PERMIT
INDEXED
TAX ID #04-369203
ON-SITE SEWAGE DISPOSAL SYSTEM
HOWARD COUNTY HEALTH DEPARTMENT
BUREAU OF ENVIRONMENTAL HEALTH

SUBDIVISION: Triadelphia Crossing LOT NUMBER: 14

ADDRESS: 14242 Meadow Lake Drive PROPERTY OWNER: Toll Bros., Inc.

BUILDER:	TOLL BROTHERS, INC. 7164 COLUMBIA GATEWAY DRIVE SUITE 230 COLUMBIA, MARYLAND 21046 410-872-9105	
PROJECT:	TRIADELPHIA CROSSING LOT 14	
LOCATION:	14242 MEADOW LAKE DRIVE TAX MAP 21, GRID 17&23 - PARCEL 97 4th ELECTION DISTRICT HOWARD COUNTY, MARYLAND	
TITLE:	PLOT PLAN	
HOUSE TYPE:	HENLEY	
DATE:	AUGUST 3, 2005	PROJECT NO. 1792
SCALE:	AS SHOWN	DRAWING 1 OF 1

PLAN
SCALE: 1" = 30'

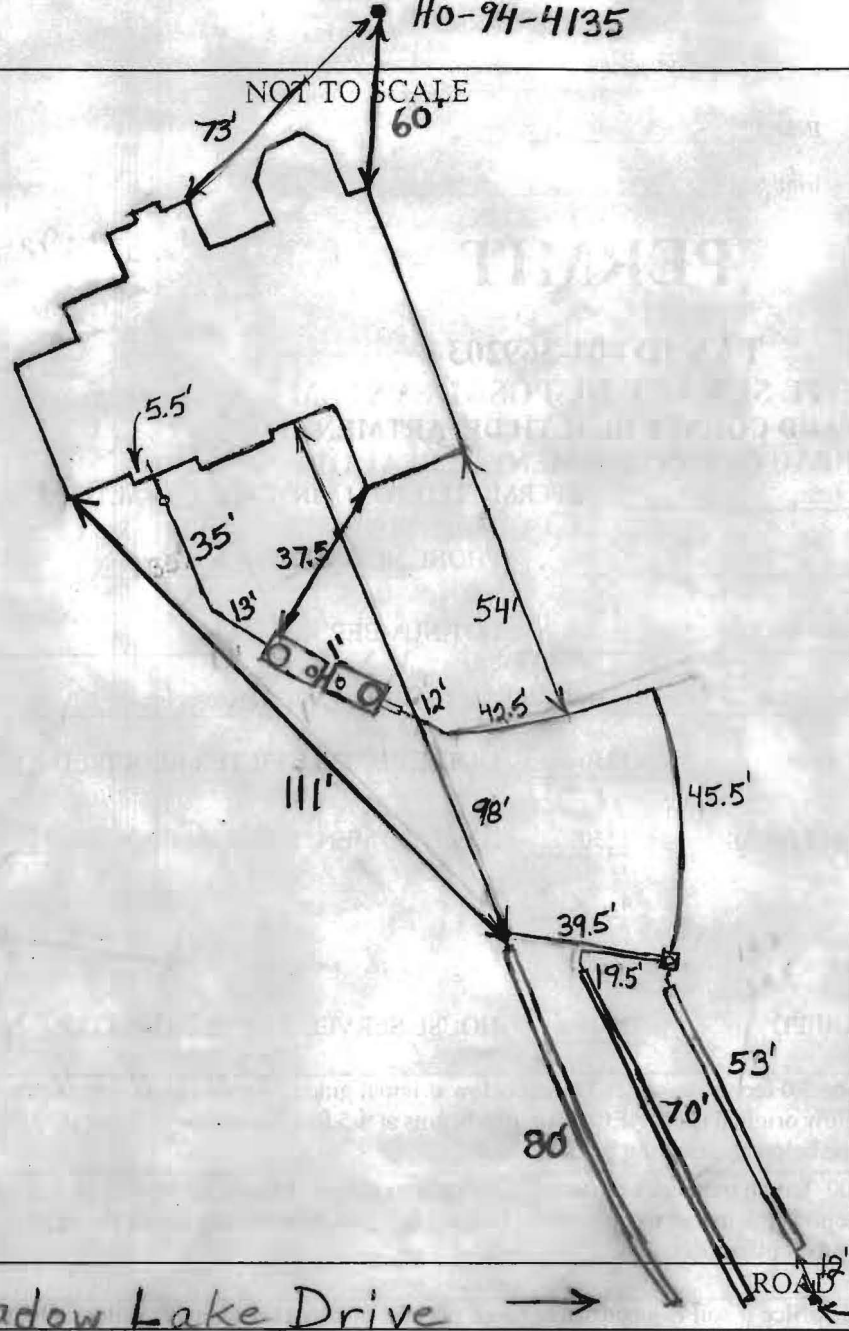
Since pump system ok to sign BP

Plenty of fall to tanks, may raise S.T. 6" @ current house invert

Ensure septic tank not in swale

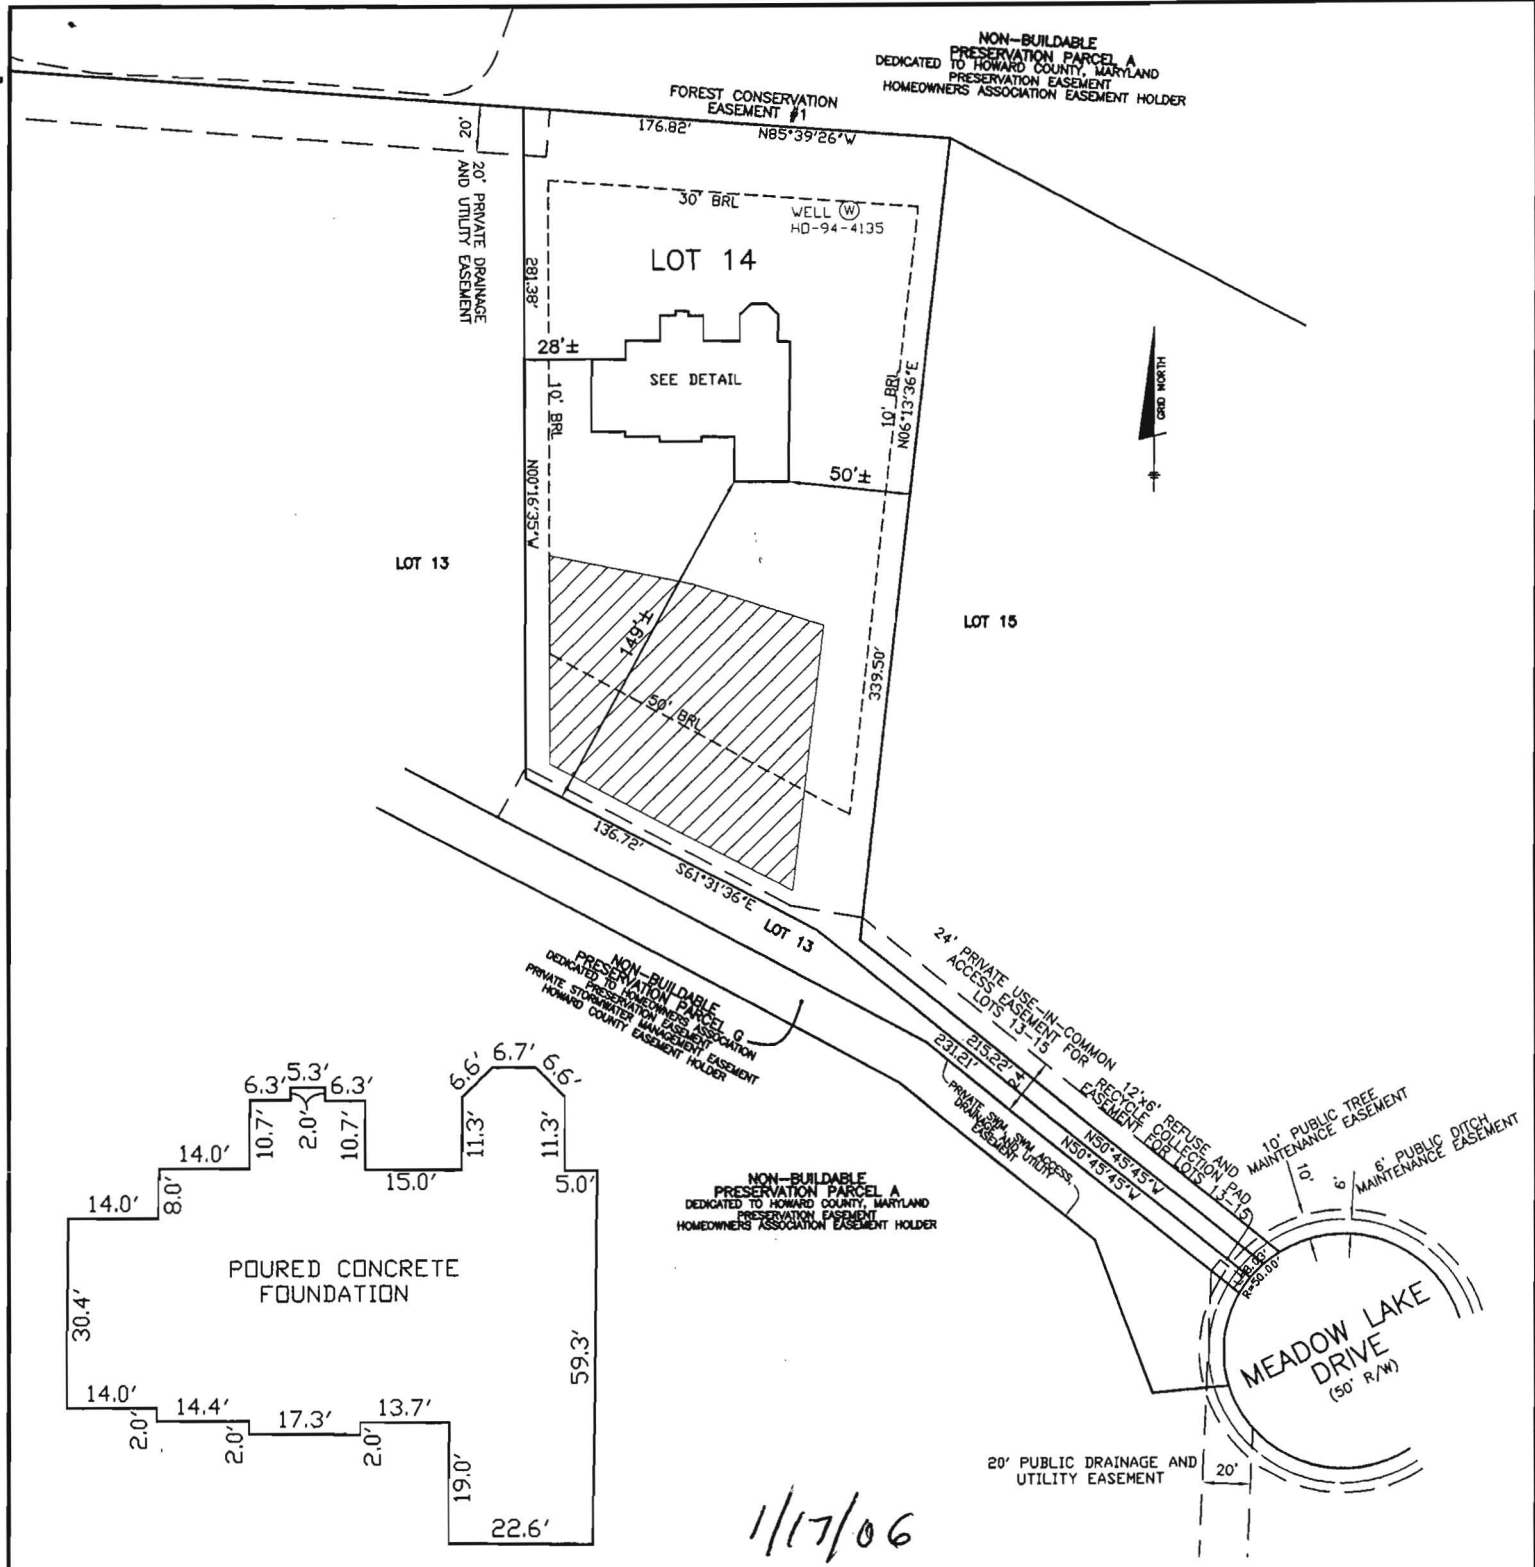
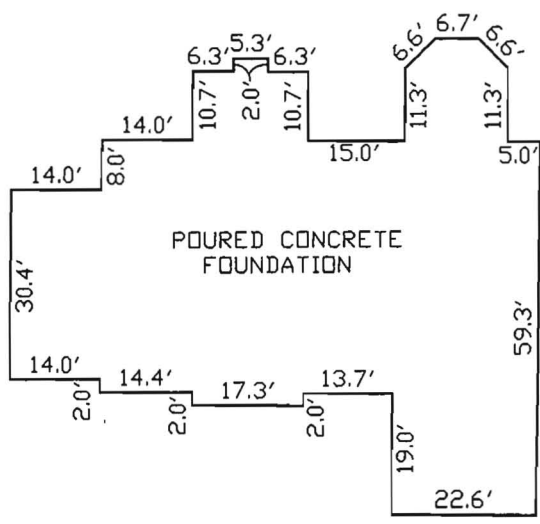
PRE-CONSTRUCTION 1/25/06 Need to get area staked. Contour accurate. (BB)

INSTALLATION 1/26/06 Easement staked. System finished except for house connection and pump and alarm test (BB)

4/26/06 House connection done (BB) 5/3/06 No water in tank (BB)

5/4/06 No water in tank (GAC) 5/8/06 Pump and alarm working (BB)

WALL CHECK
**TRIADELPHIA CROSSING
PHASE ONE LOTS 1-22**
LOT No. 14
14242 MEADOW LAKE DRIVE
4TH ELECTION DISTRICT
HOWARD COUNTY, MARYLAND
SCALE: 1" = 80' DATE: 12/14/05

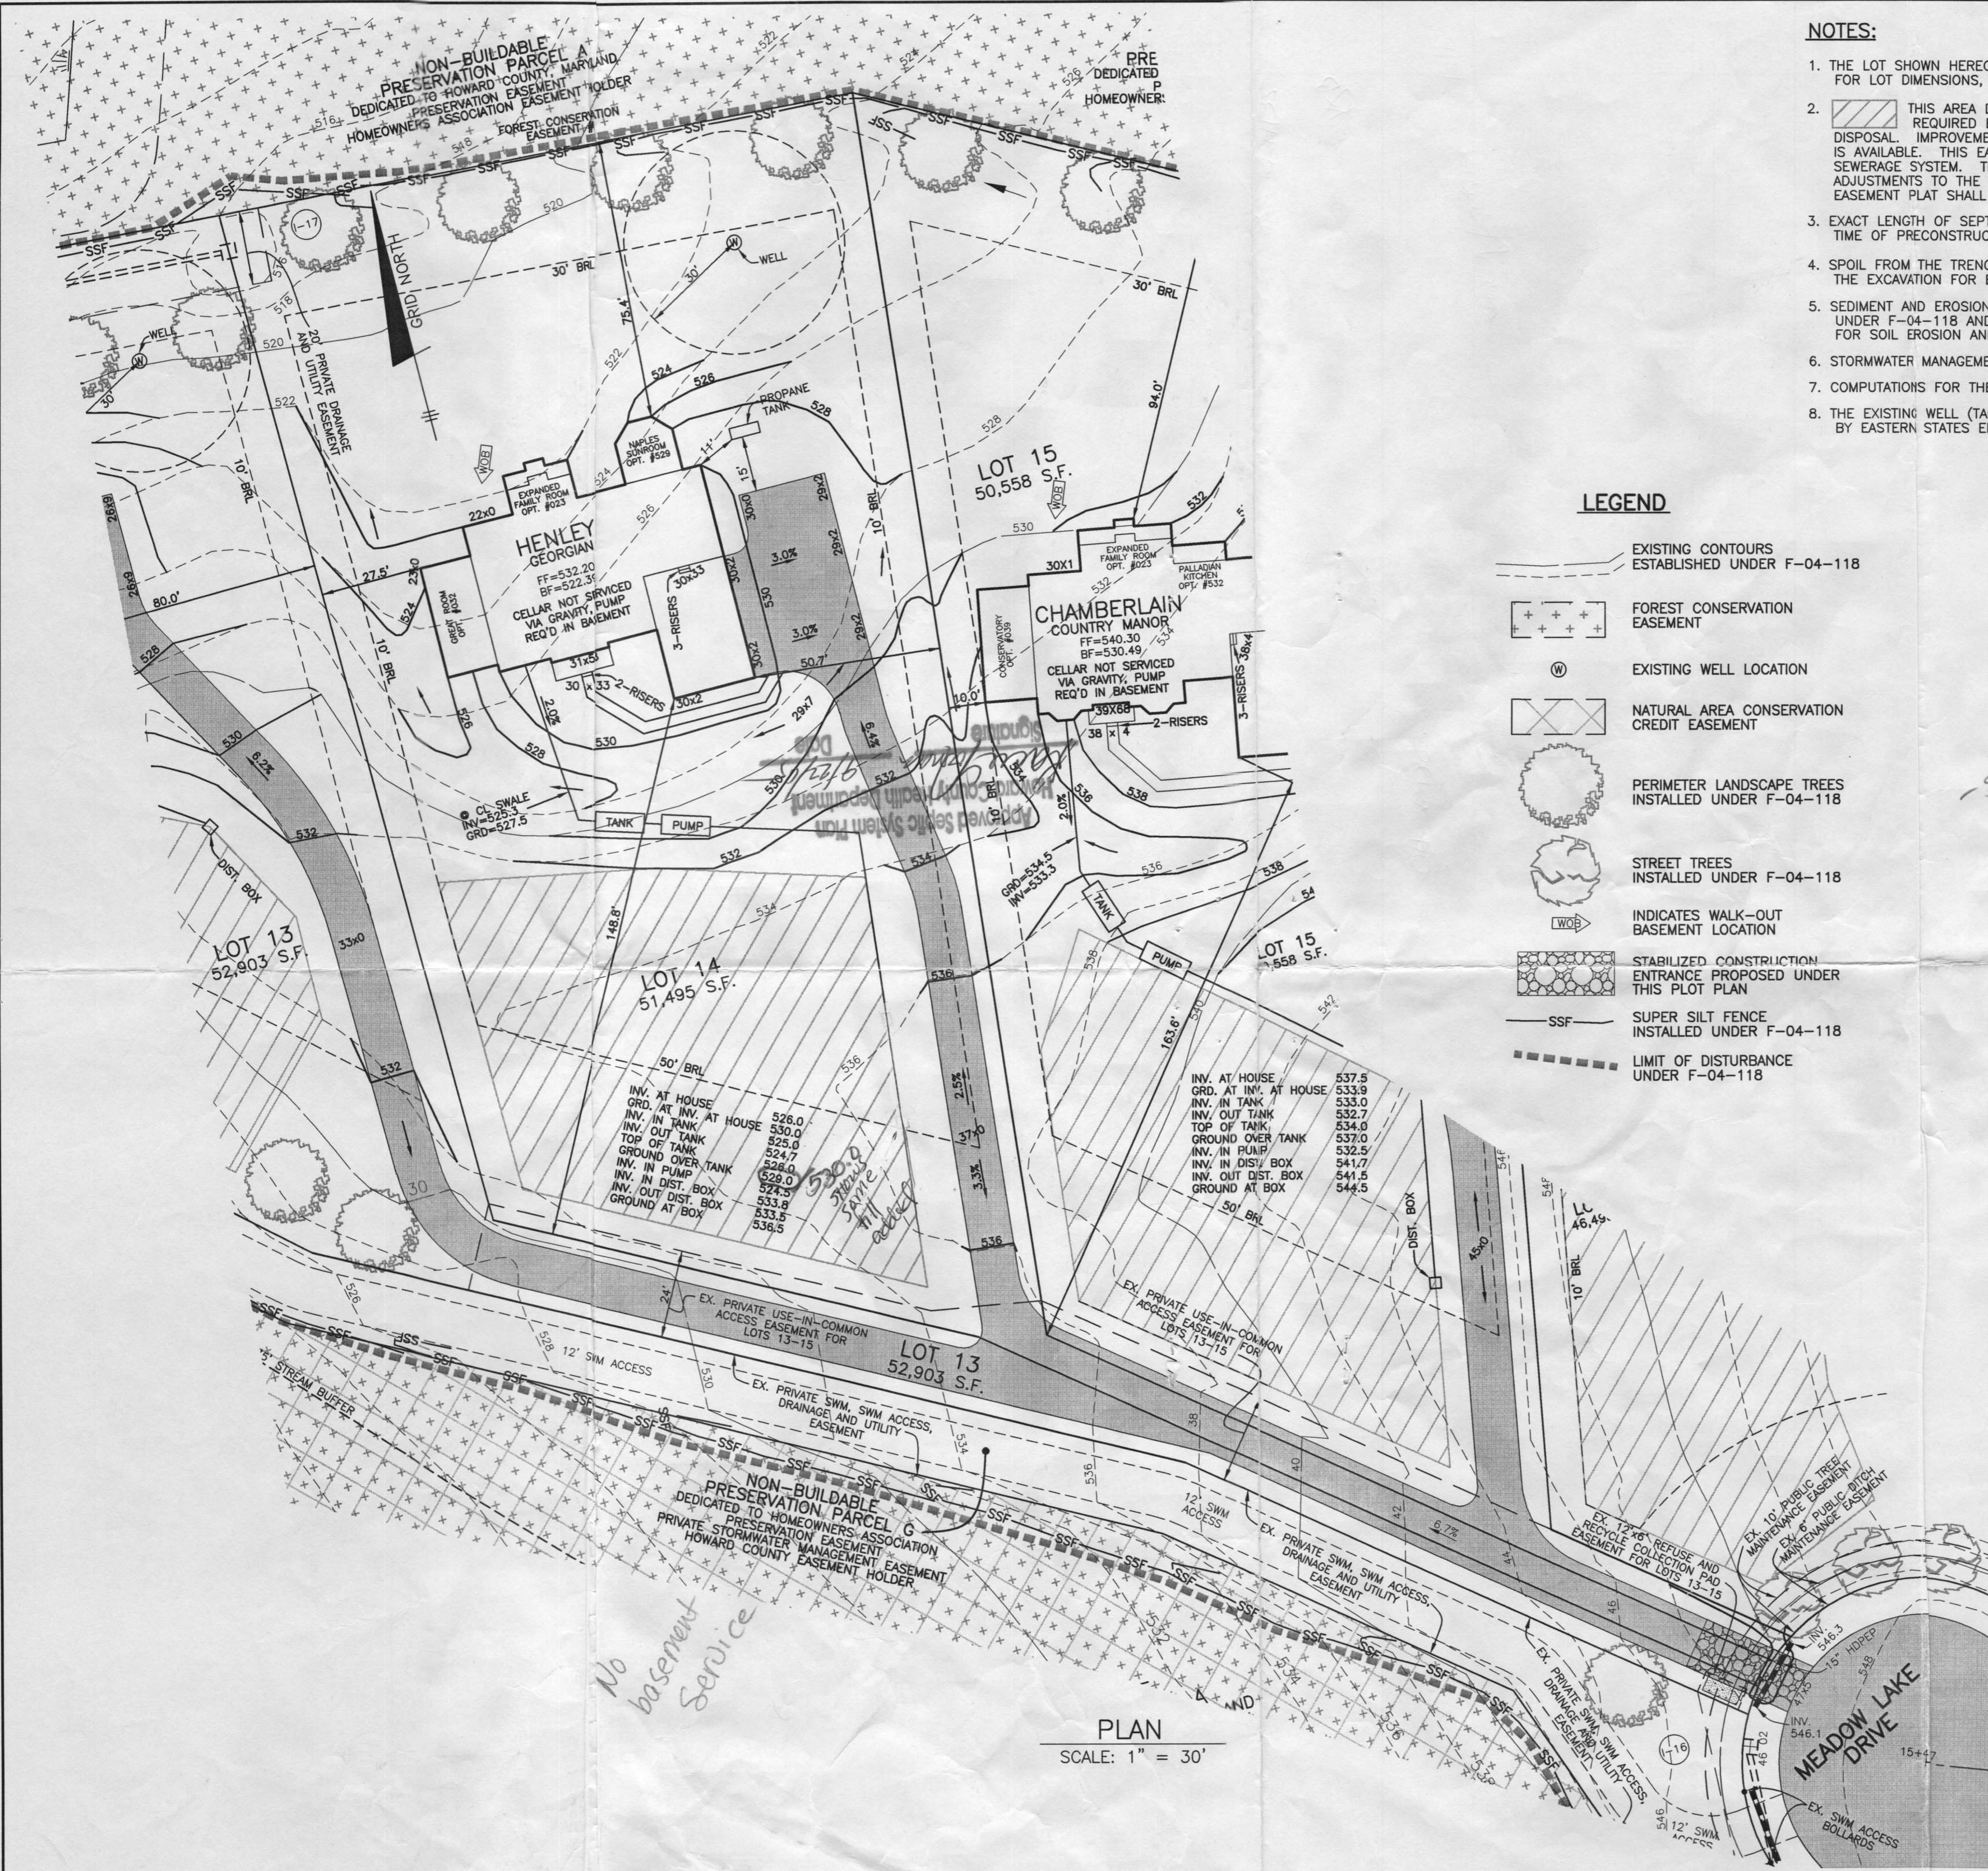
1/17/06
House located as per B.P. Plan. House raised ~1'!
BB
FIRST FLOOR ELEVATION = 532.4'
OFFSET DIMENSIONS TO PROPERTY LINES ARE ± 1'
